STAFF RECOMMENDATION

NCPC File No. UR10/6685

**FORT LINCOLN URBAN RENEWAL AREA (FORT LINCOLN NEW TOWN)
WASHINGTON GATEWAY REGIONAL RETAIL CENTER**
Bounded by New York Avenue, South Dakota Avenue,
33rd Place and Fort Lincoln Drive, NE
Washington, D.C.

September 28, 2006

PROPOSED SITE PLAN

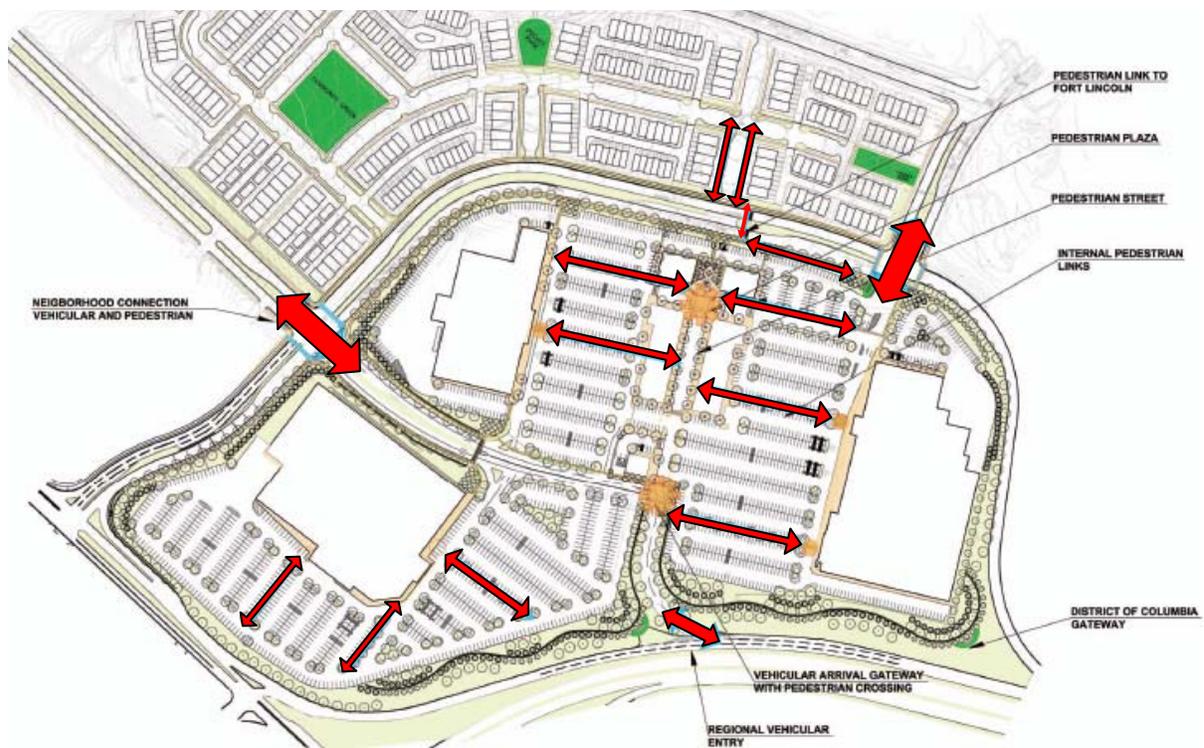
The concept design does not, however, fully respond to more detailed design requirements for façade design, building orientation, parking, landscaping, loading areas, and pedestrian links to Anacostia Park. A majority of the buildings are not oriented towards 33rd Place and Fort Lincoln Drive, and much of the primary façades of the big-box stores are blank. Landscaping for parking areas, street edges, and loading areas is not adequate given the deficiencies in those areas with regard to building design. The number of parking spaces, accommodated solely by surface lots, far exceeds the Plan's required minimum as well as the minimum spaces required by the zoning regulations. The development team has determined that structured parking is not economically or functionally feasible primarily due to soil conditions, but staff has learned through consultation that the large paved surface areas may generate excessive runoff; further investigation as part of the National Environmental Policy Act (NEPA) review process is needed before making a final determination on this issue.

GRAPHIC DEPICTION OF STAFF RECOMMENDATIONS

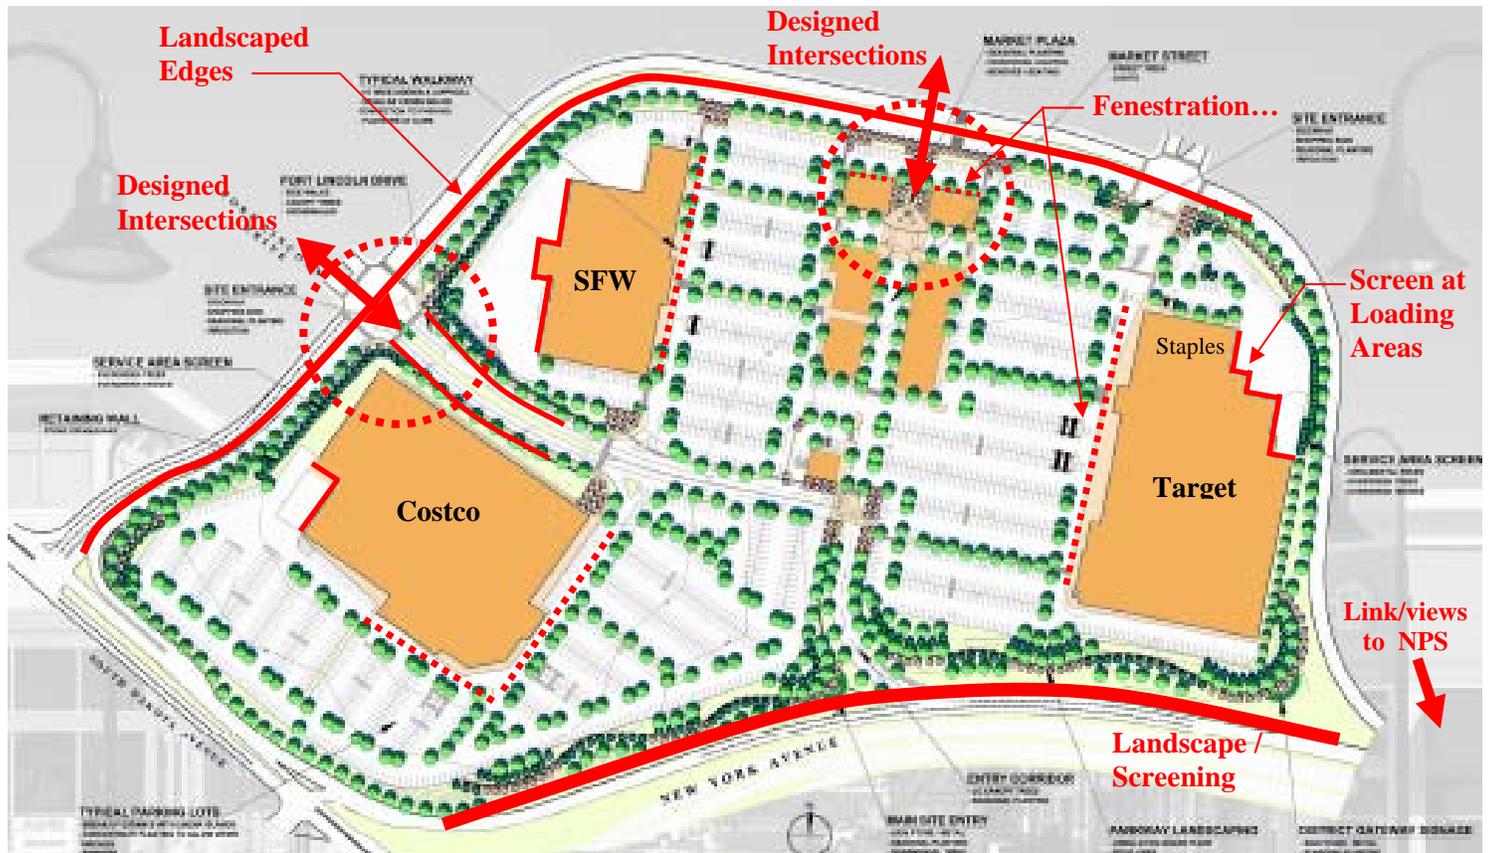
As the preliminary design is further developed, the applicant is required to do the following in order to address the items that do not fully comply with the plan:

- Develop more fully pedestrian connections to adjacent housing areas and Anacostia Park through the design of crosswalks, site lighting and landscaping at major intersections with Fort Lincoln Drive and 33rd Place.

- Incorporate more extensive fenestration, surface treatments, or landscaping to minimize the effects of blank façade areas of large-scale retail and façades of buildings fronting on Fort Lincoln Drive. The treatments that may be used include additional fenestration, changes in façade materials/plane, landscaping, and/or other surface treatments (i.e., trellises, color, texture, etc.).

- Develop detailed landscape designs and lighting alternatives to minimize visual impacts to adjacent streets and residential development as well as enhance views and vistas to/from/within the site (including views to the Anacostia River). Since much of the proposed retail design is not oriented toward Fort Lincoln Drive, landscaping or other site elements along that edge should be extensive and designed to provide for year-round screening, especially adjacent to loading areas.

- Create a parking and circulation plan that incorporates trees, shrubs, and other landscape elements that reduce adverse visual impacts and may aid in minimizing stormwater runoff. NCPC also encourages the applicant to incorporate low-impact design strategies to minimize the effects of stormwater runoff on the Anacostia River resulting from expansive paved areas.

- Prepare an Environmental Assessment (EA) or Environmental Impact Statement (EIS) as required by the National Environmental Policy Act (NEPA) and NCPC's Environmental and Historic Preservation Policies and Procedures. The EA or EIS is required to guide the decision making process for, and be reflected in, the preliminary and final site and building plans for this project on federal land.

Additionally, staff recommends screening methods to minimize visual effects of rooftop mechanical equipment from adjacent residential areas and circulation arteries.
